Tentative Interim Amendment

NFPA[®] 72[®]

2025 Edition

TIA 25-2

Figure A.3.3.157 Typical Intermediary Service Provider Concept.

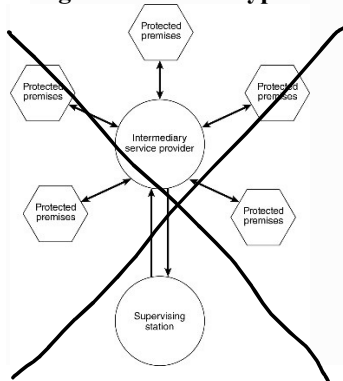
1. Delete 3.3.157, A.3.3.157, and Figure A.3.3.157 as follows:

Figure A.3.3.157 depicts the location of an intermediary service provider in the communications cloud relative to a protected premises and a supervising station. (SIG-SSS)
